NEEDHAM PLANNING BOARD Tuesday, November 7, 2023 7:00 p.m.

- 7:00 p.m. Major Project Site Plan Special Permit No. 2023-03: Neehigh LLC, 93 Union Street, Suite 315, Newton Center, Petitioner. (Property located at 629-661 Highland Avenue, Needham, Massachusetts). Regarding request to demolish the five existing buildings on the property and build a single two-story 50,000 square feet Medical Office Building (25,000 square feet footprint) with two levels of parking (one at-grade and one below grade) totaling two hundred and fifty (250) spaces. Please note: This hearing has been continued from the September 5, 2023 and October 17, 2023 Planning Board meetings.

The applicant intends to demolish the five existing buildings on the property and build a single two-story 50,000 s.f. Medical Office Building (25,000 s.f. footprint) with two levels of parking (one at-grade and one below grade) totaling two hundred and fifty (250) spaces. The two stories of the building itself are located directly above a parking area that is partially above grade and thus for zoning purposes counts as an additional story; and a three-story building is allowed in this zoning district. The proposed project will

Highland Ave MOB / Site Diagram / 14 July 2023

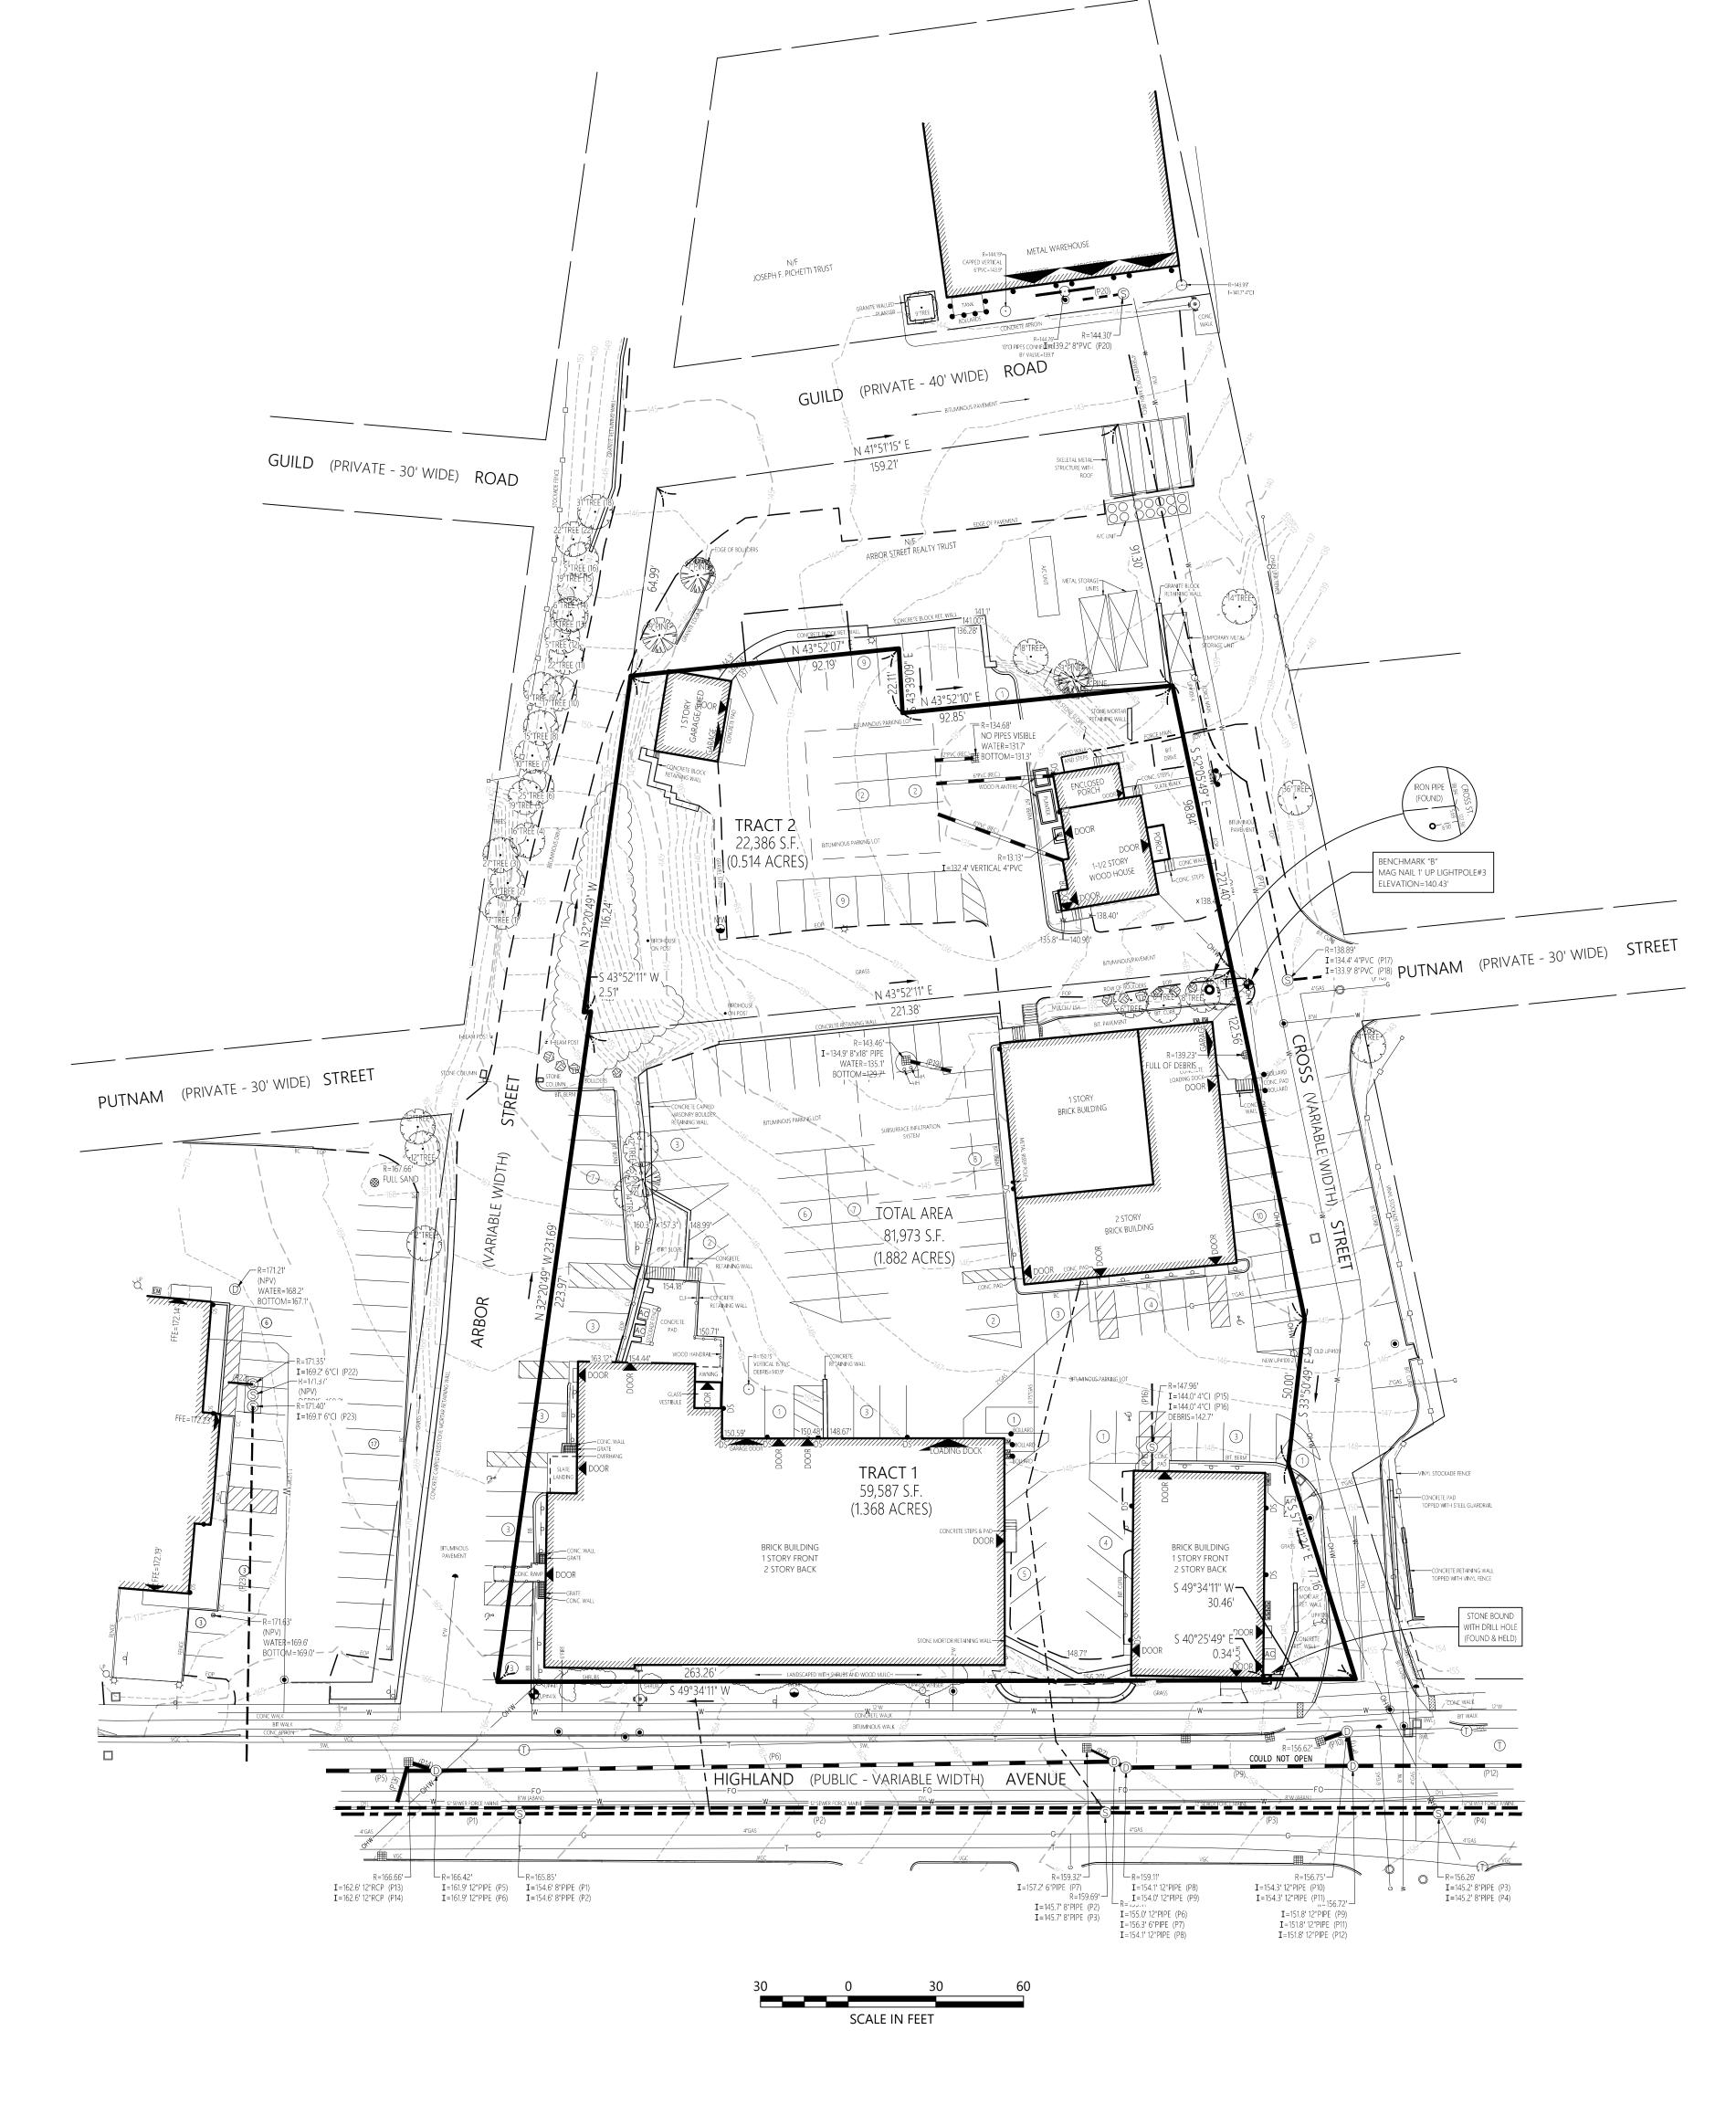
There appears to be a discrepancy/error in the table on page P3 (Site Diagram) of the plans, which indicates the setback from Highland to be 57.75'/62.25'. This conflicts with the site plan on page C3.01 which shows a uniform setback of 38' from Highland.

Drawing Title:Layout and
Materials Plan

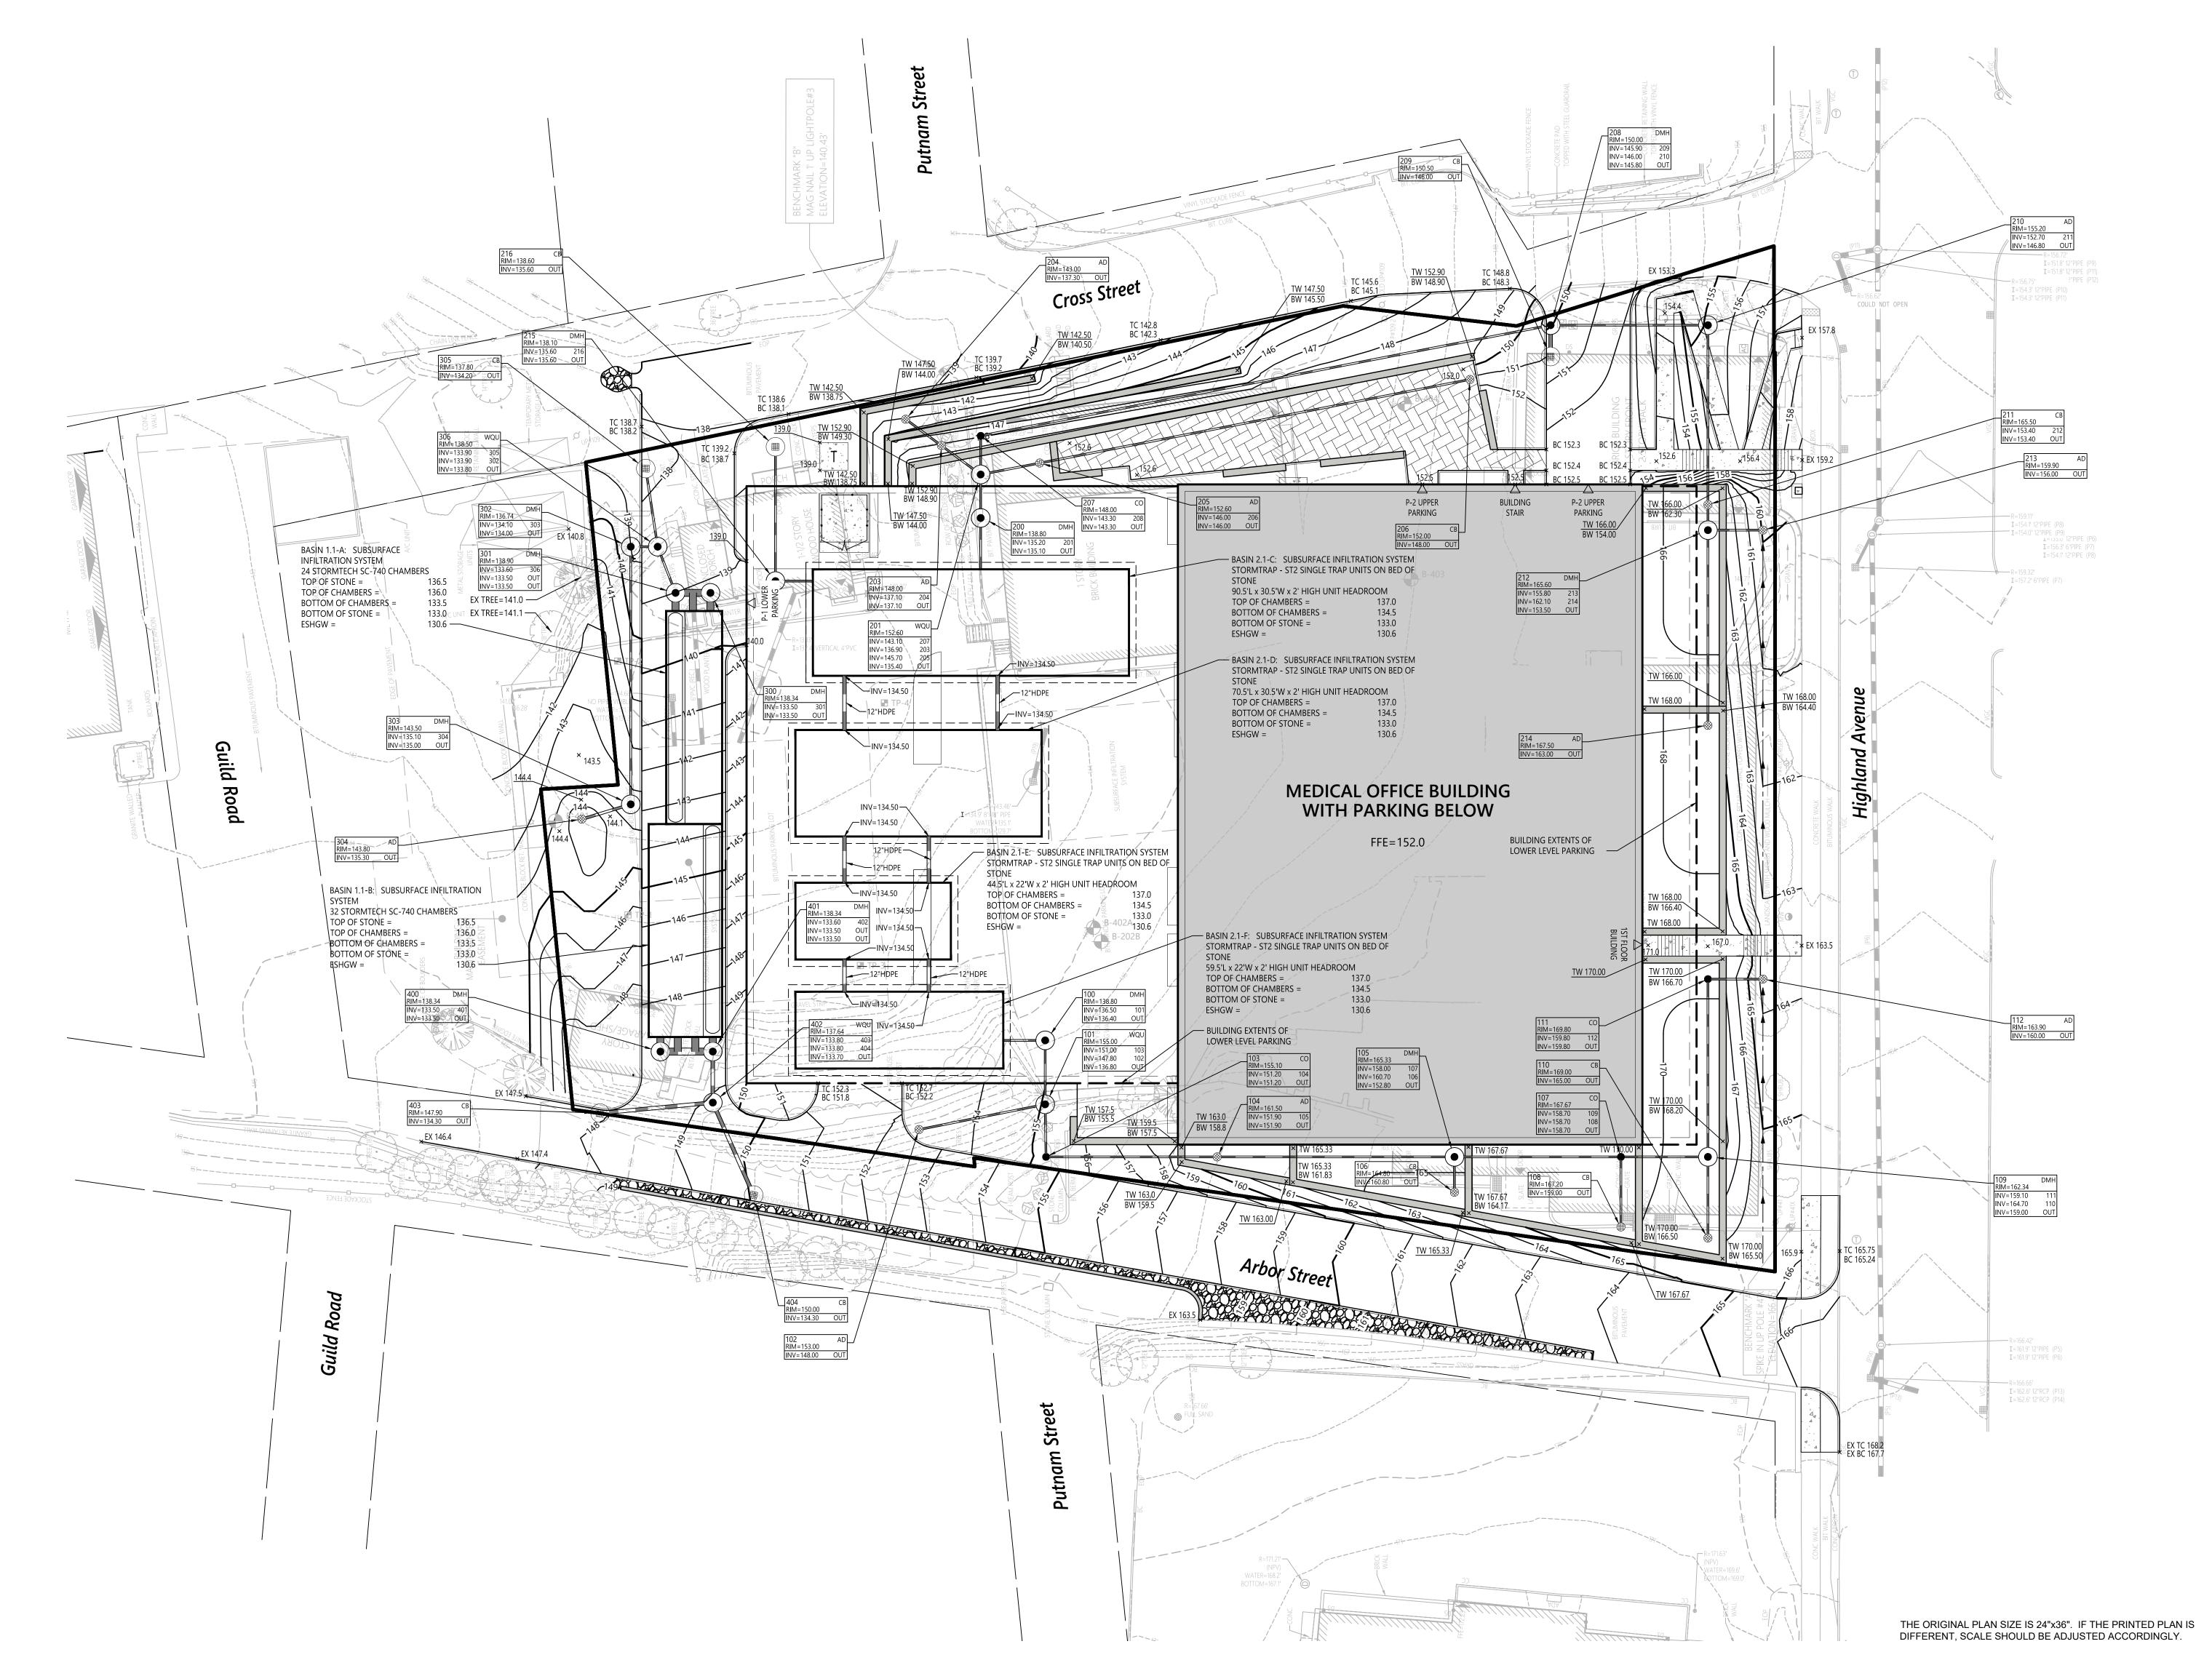
- 40. Sheet C3.01 depicts a pedestrian crosswalk across Arbor Street at the Highland Avenue intersection. This approach should also include a bike crosswalk and ramp to accommodate the sidewalk level bike lane.

Please see the attached PDFs for the revised civil site plans (C1.01, C3.01, C4.01, C5.01), truck turning (deliveries and garbage) and architectural upper parking level plan. These plans collectively depict the following changes per traffic and board comments:
